H. Henschel, I. Tsurin		
Title Data processor and VME interface		
Size	Document Number BST Pad trigger system: Download card	Rev 1
Date:	Friday, September 23, 2005	Sheet 2 of 6

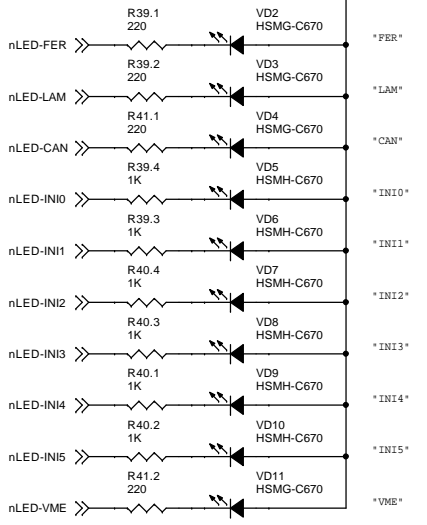
05.08.03 The lack of filtering capacitors for the ALTERA core and I/O voltages leads to spiky signals which may potentially cause a problem.

05.08.03 The "SysCLK" signal is taken directly from the VME bus without any buffer. The data conflict is possible between the ALTERA chip and the VME crate controller.

05.08.03 There is no systematic in assignment of the following signals: TCK, TMS, TDI, TDO.
